Notification of a non-key Decision taken by the Cabinet Member for Environmental Sustainability and Regeneration

RPC CPZ Cambridge Road Area, Raynes Park – Statutory consultation.

Drawing No. Z78-212-01
Revision C
Classification REPORT
Scale N.T.S.

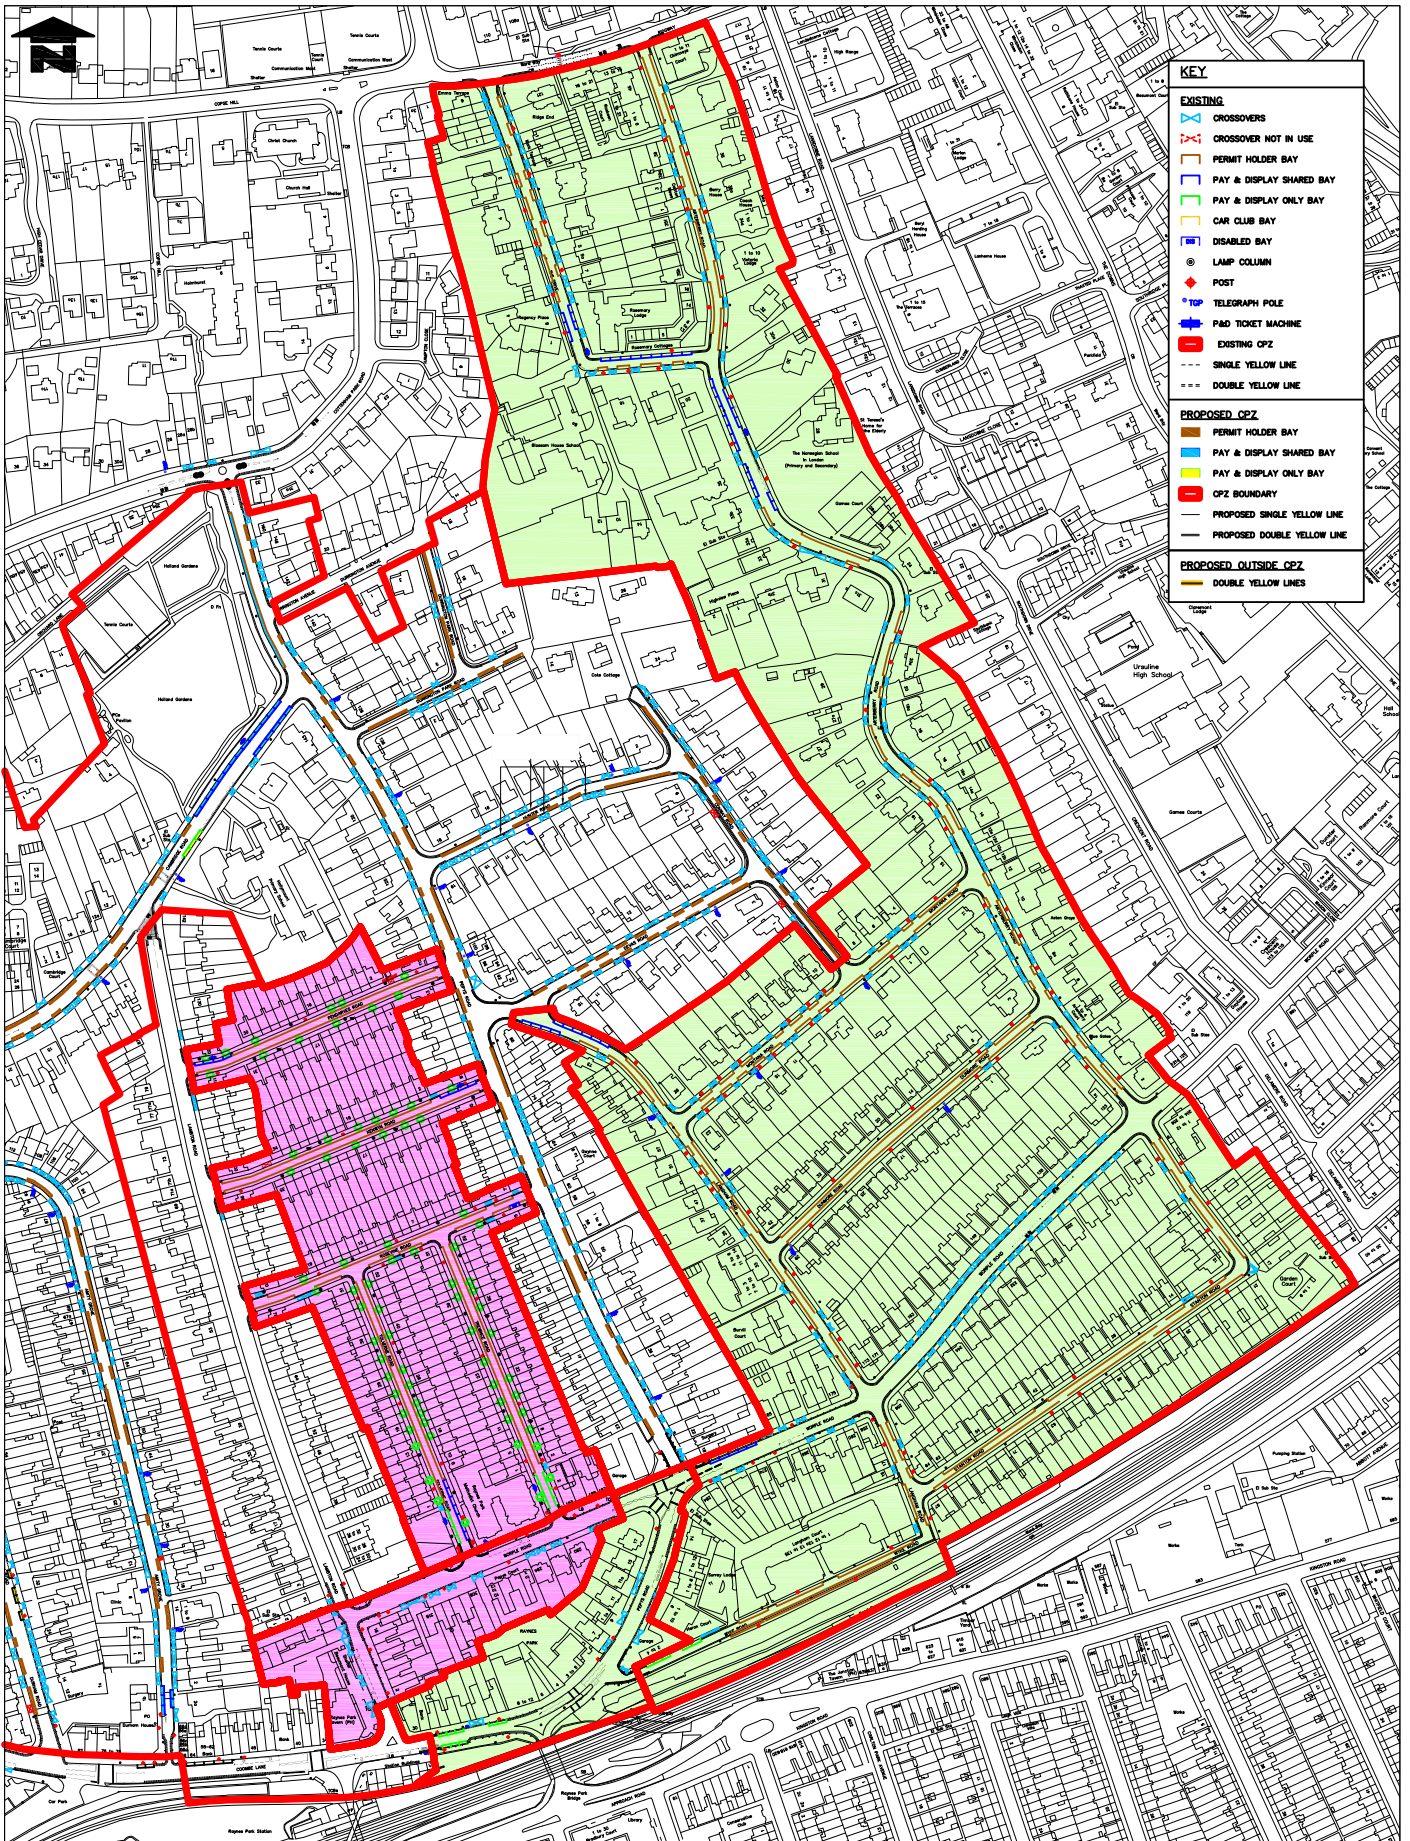
- 4.14 In response to the feedback received from residents, the following amendments have been made to the original design. These are set out below and shown on Drawing No. Z78-212-01 Rev C in Appendix 1.

On the current plans, Z78-212-01 Rev B CPZ RPC Sheet 2 of 2, there is a single yellow line proposed between the existing cross-over between No 42 and No 44 Amity Grove. There is plenty of room for a car to be parked in this space and I can confirm that cars have routinely parked here for at least the last 14 years that I have been resident on Amity Grove without incident.

4. For detail on parking bays we were invited to go to www.merton.gov.uk/cpzrprz, but the plan on that site (RevB CPZ RPC Sheet2) continues to show, uniquely, a permit holder bay across the whole width of our authorised crossover, which was installed under Council arrangements in 2011. We raised this issue and with some delay and after intervention by Councillor Rod Scott, the Council agreed that this was an error and undertook to correct it, see Leonardo Morris e-mail 24 September 2013.

Officer Comment,

This will be altered on the plan.
